VENTURA UNIFIED SCHOOL DISTRICT

VETURA HIGH SCHOOL STADIUM UPGRADES AND SITE IMPROVEMENTS

ADDENDUM #03

Bid Addendum No. C

L2.01

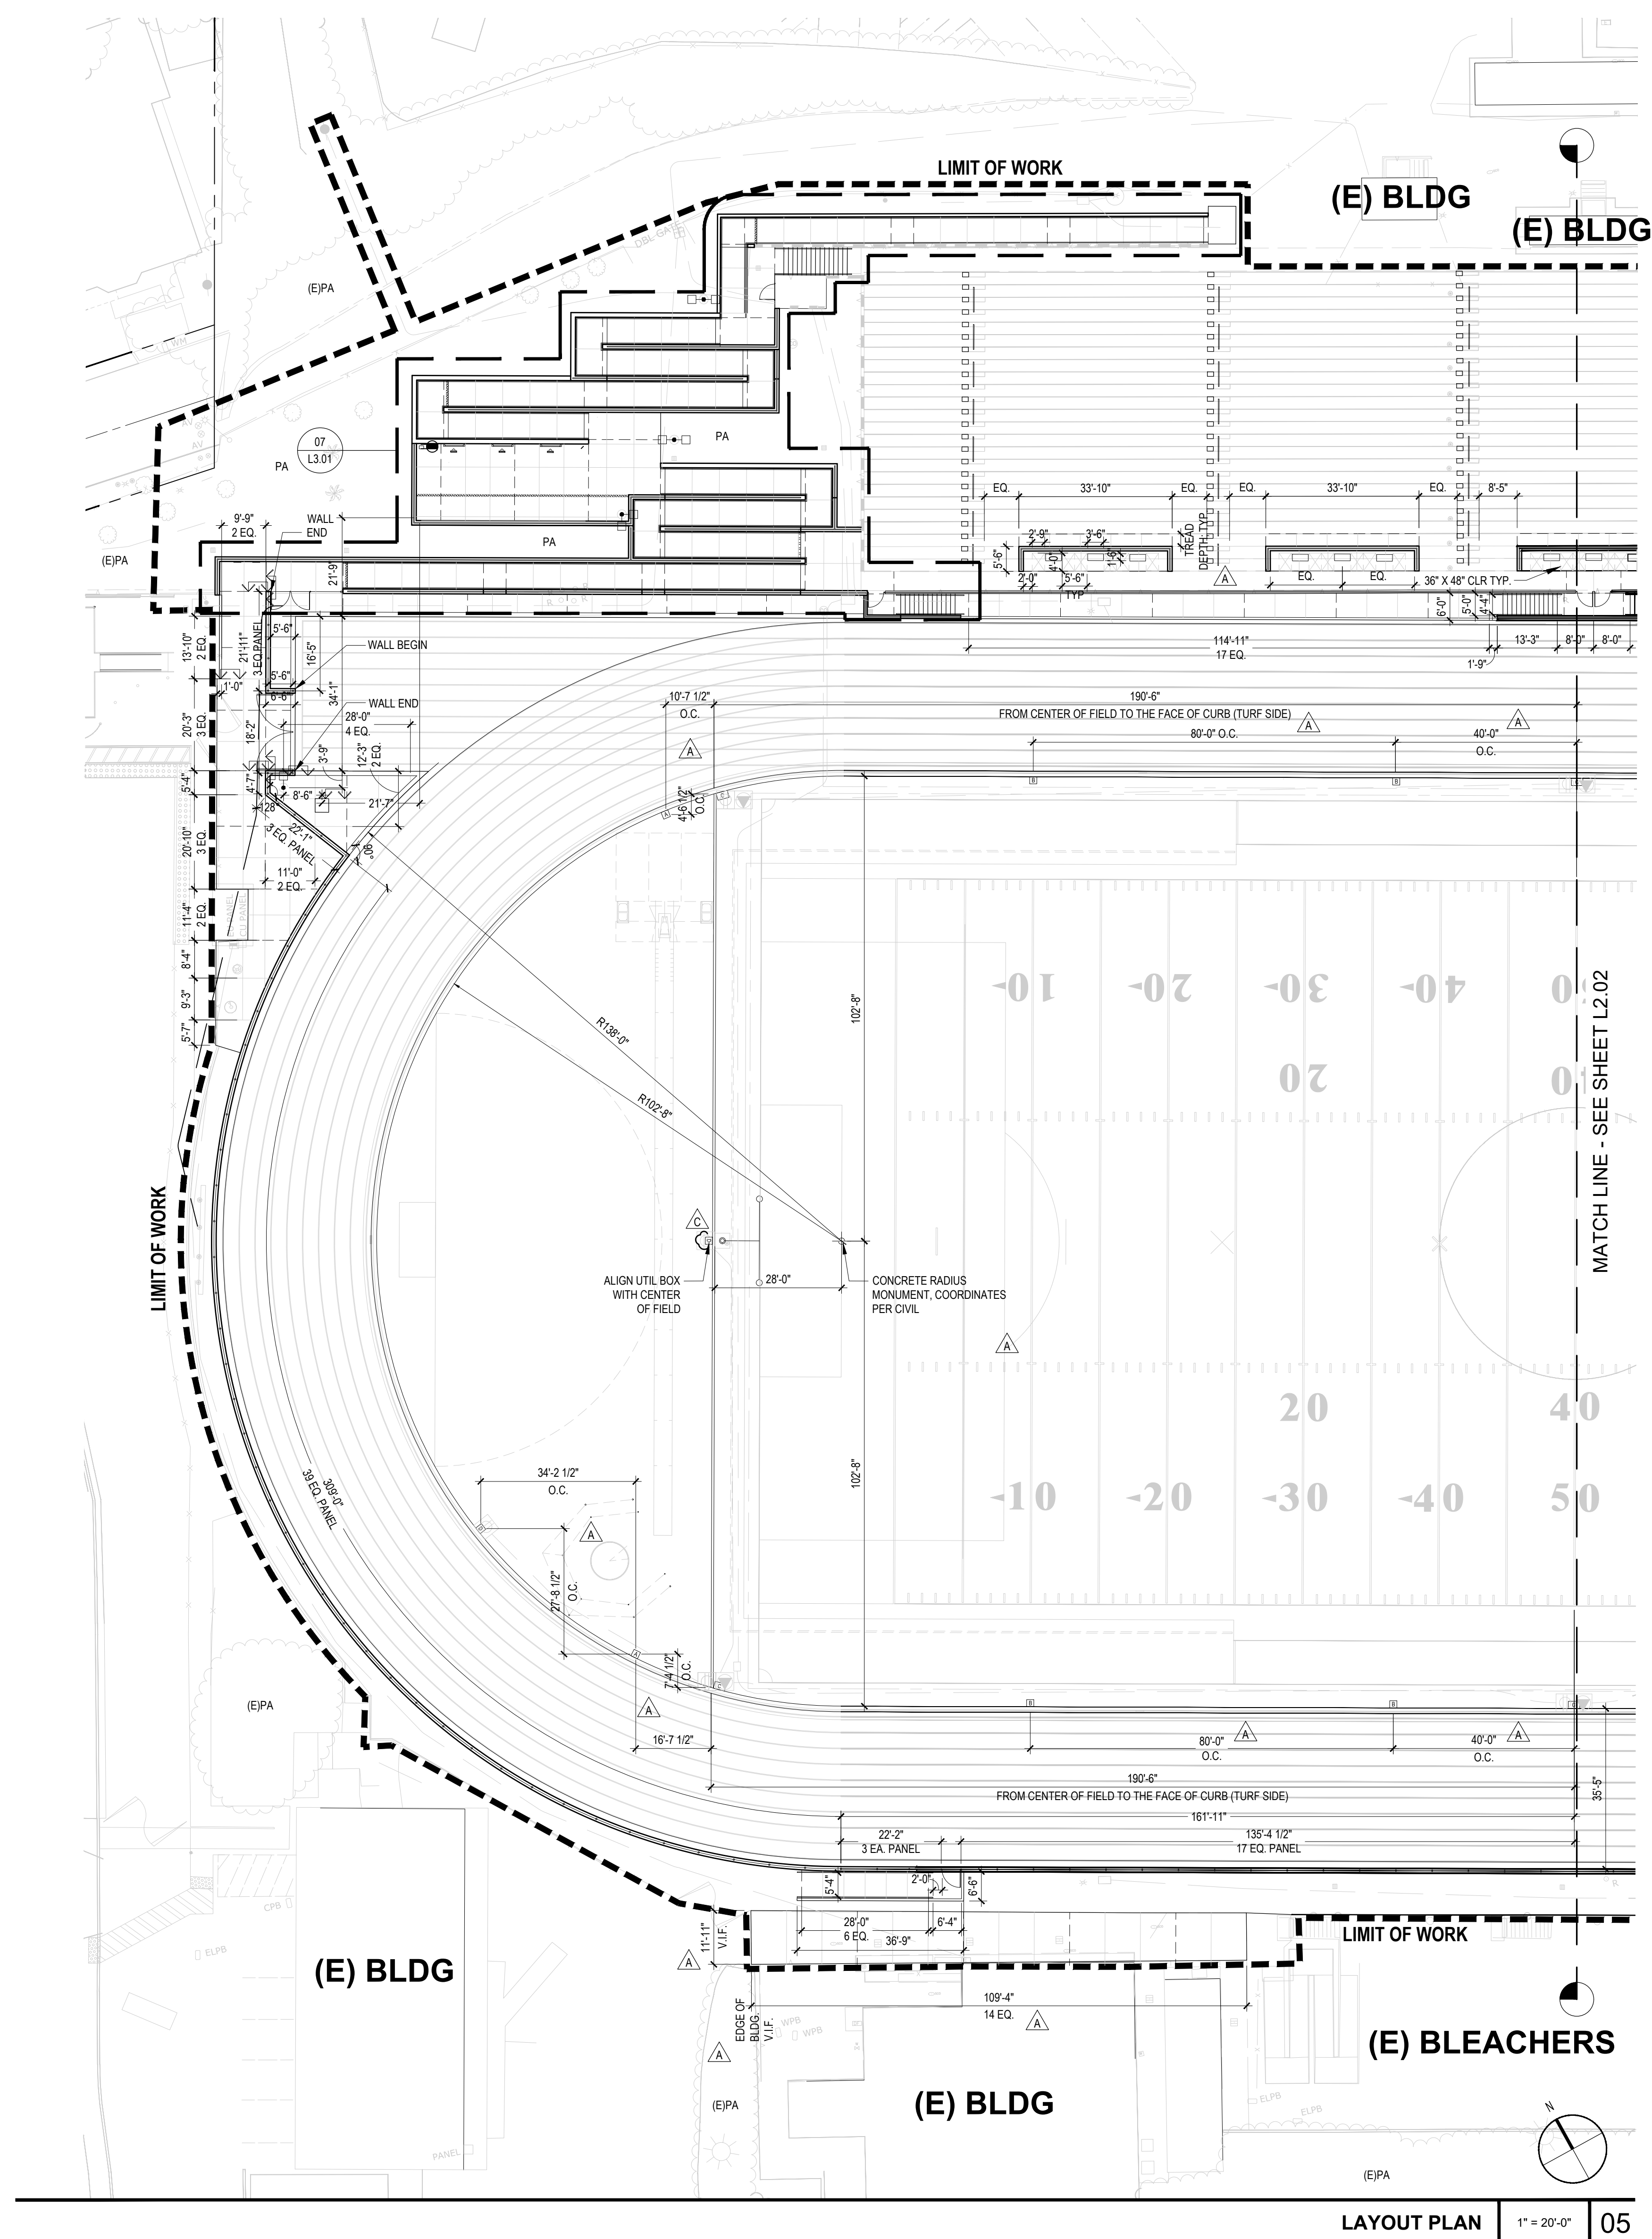
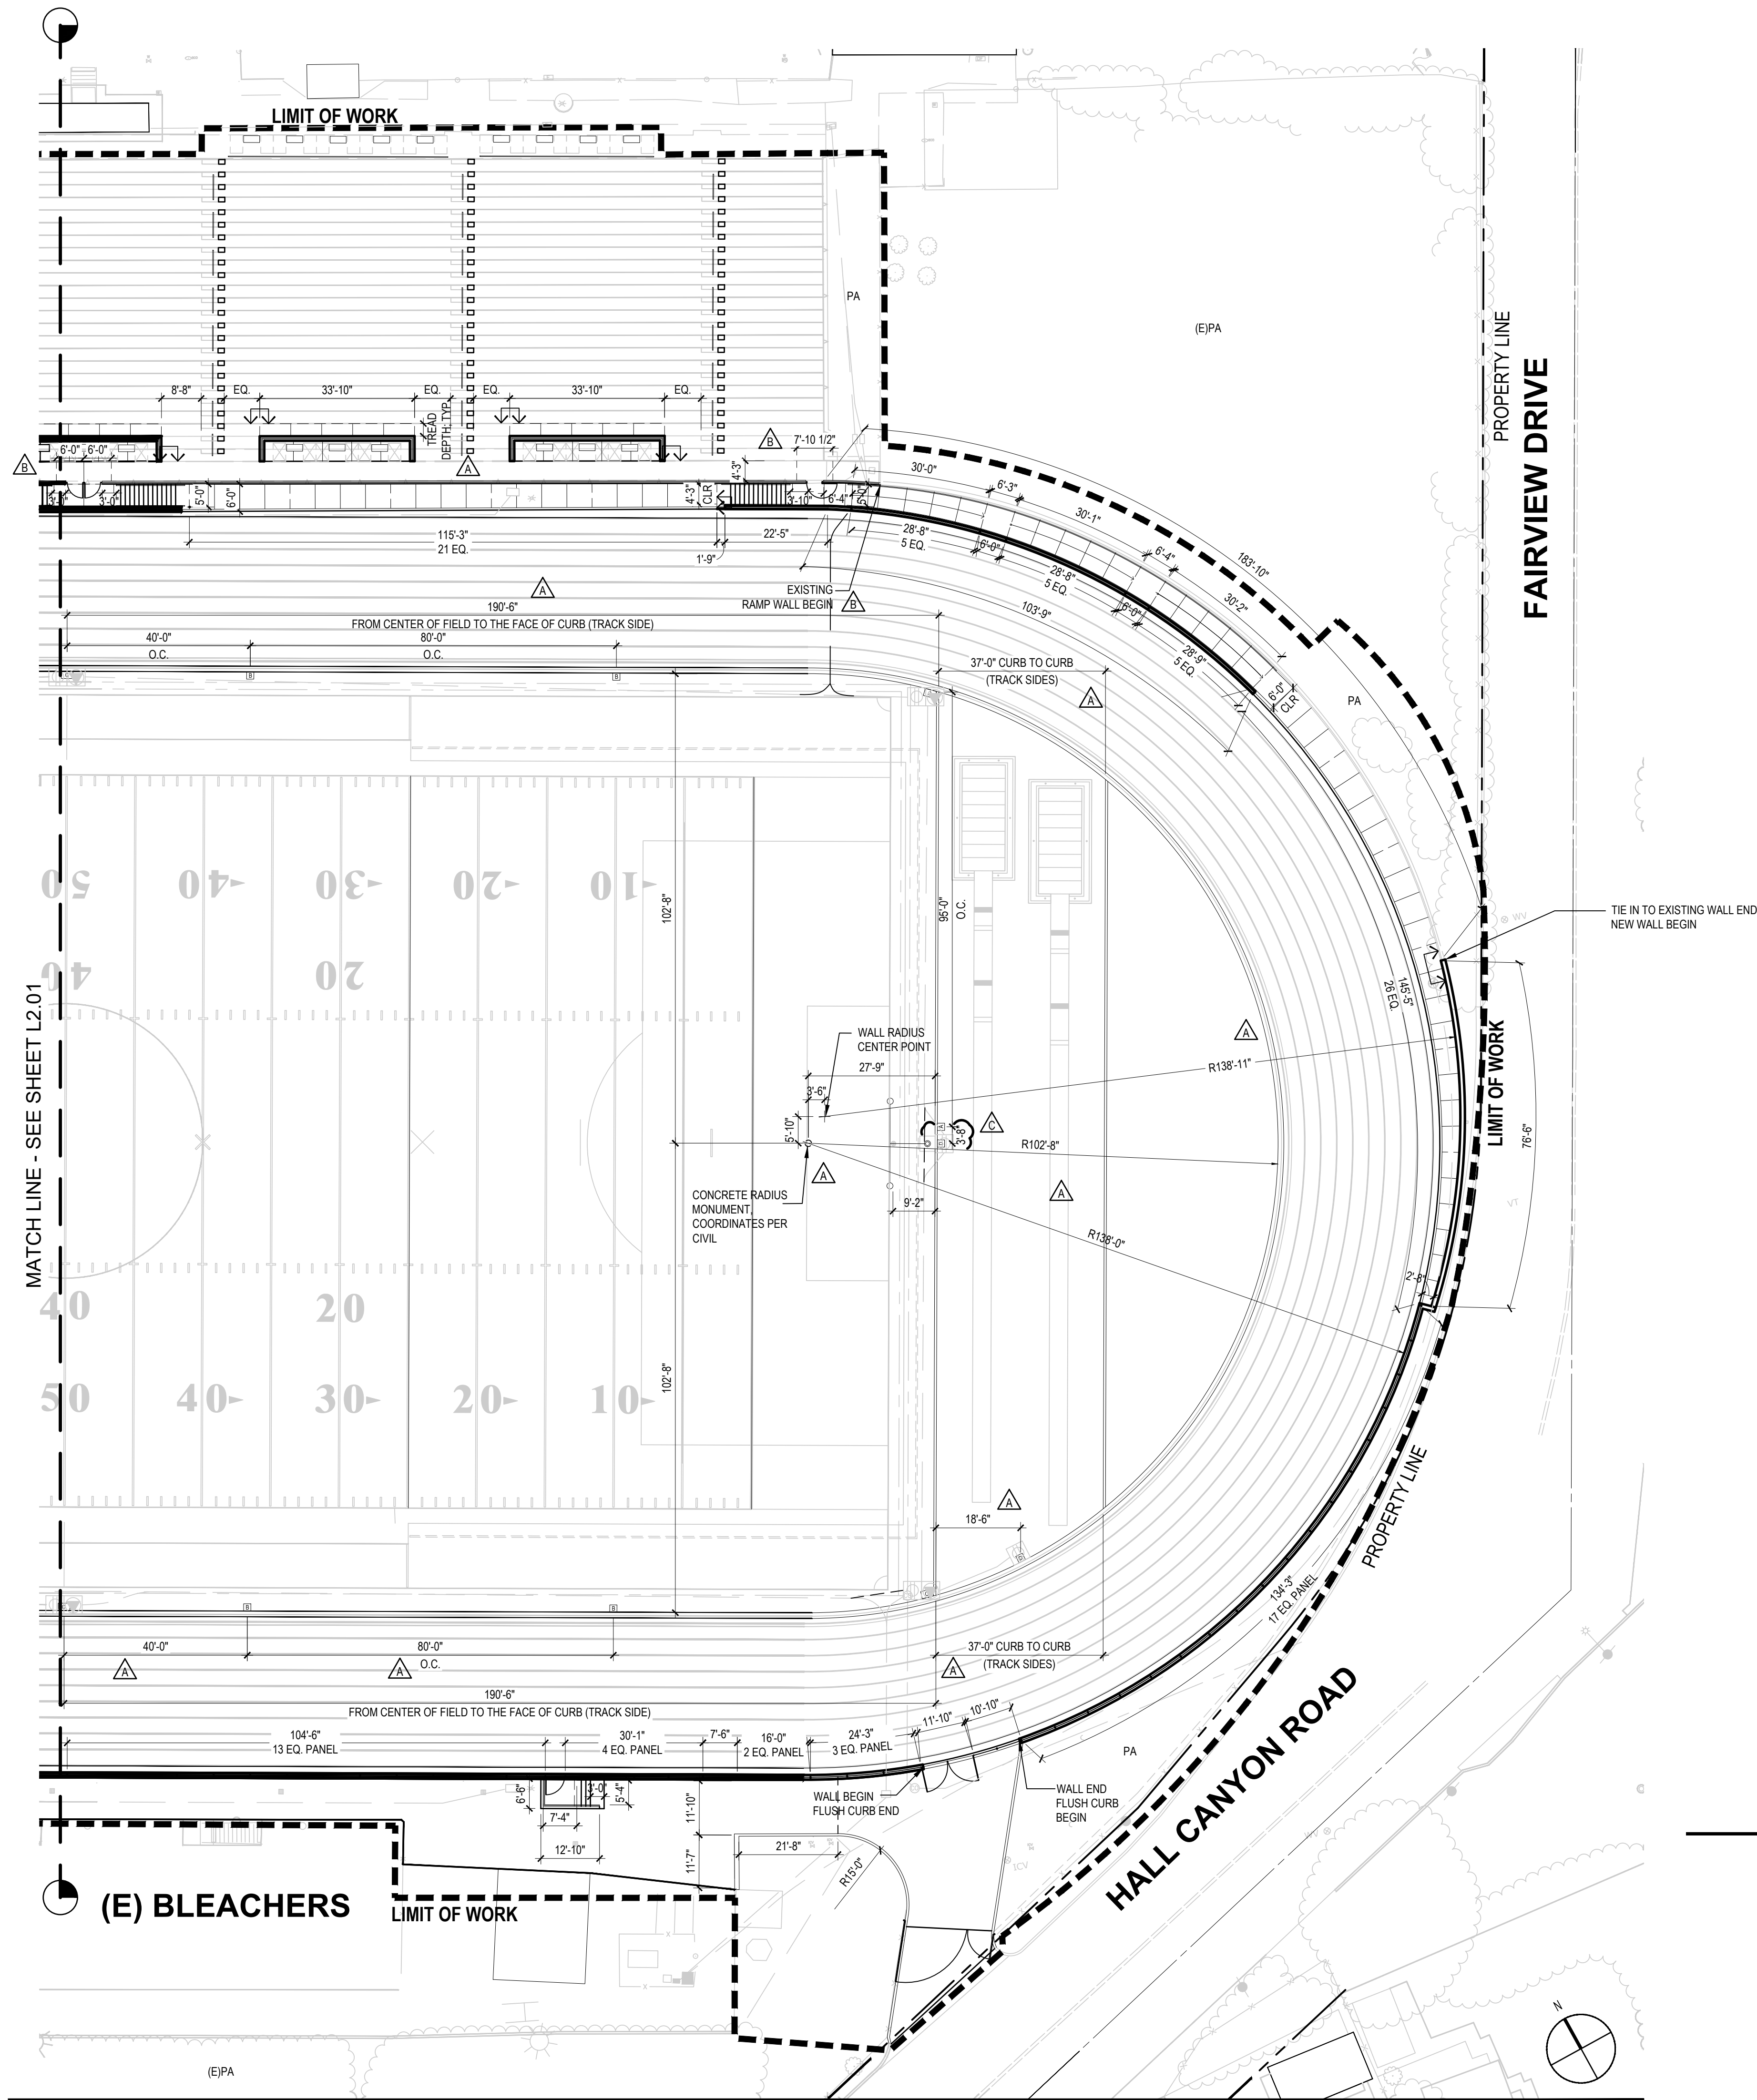
| Item No. 4 | L2.01 LAYOUT PLAN: <ul style="list-style-type: none">- Callout for the new Utility Box at football field goal post added. |

L6.02

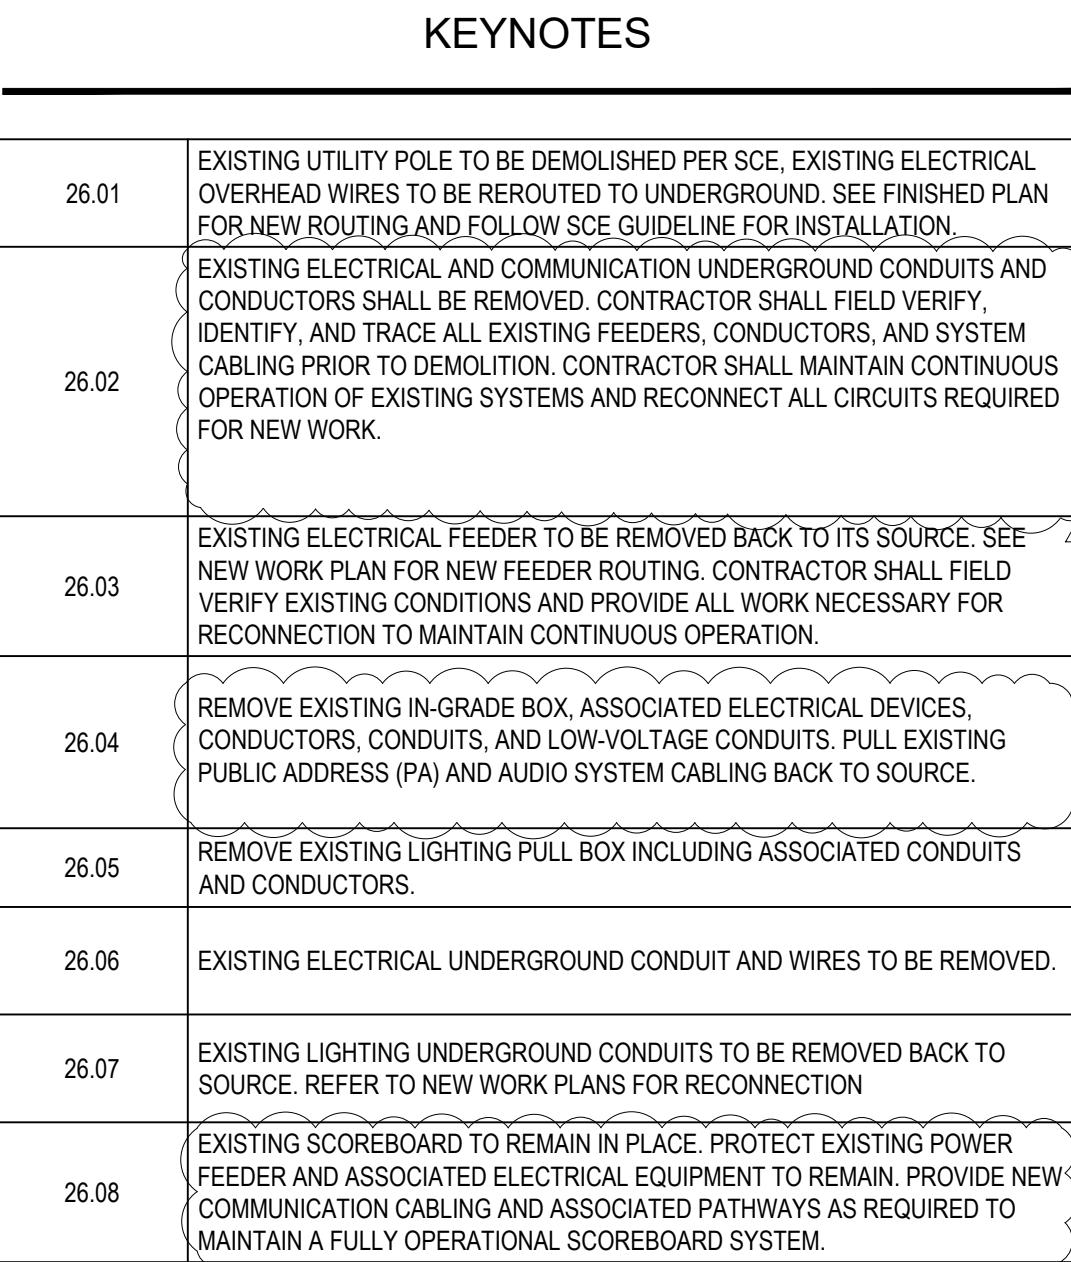
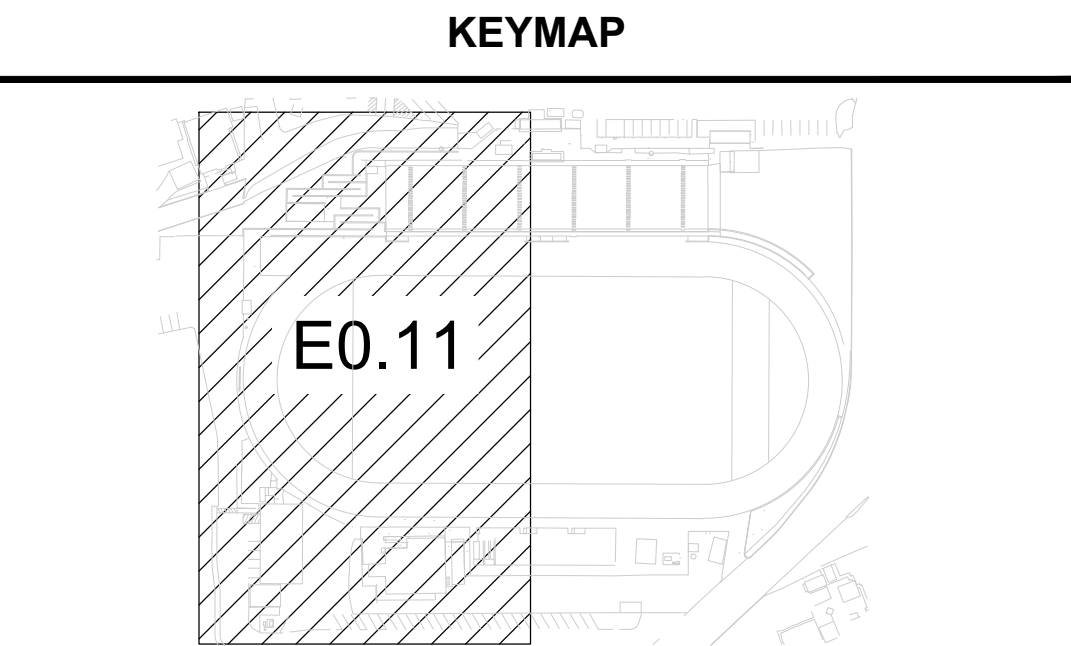
| Item No. 7 | L6.02 IRRIGATION PLAN: <ul style="list-style-type: none">- Pipe sizes added to the site plan. |

REQUESTED CLARIFICATION:
Please provide lateral size for drawing L6.01 and L6.02.
RESPONSE TO CLARIFICATION:
L6.01 & L6.02 are updated with pipe sizing and reissued as part of Addendum C.
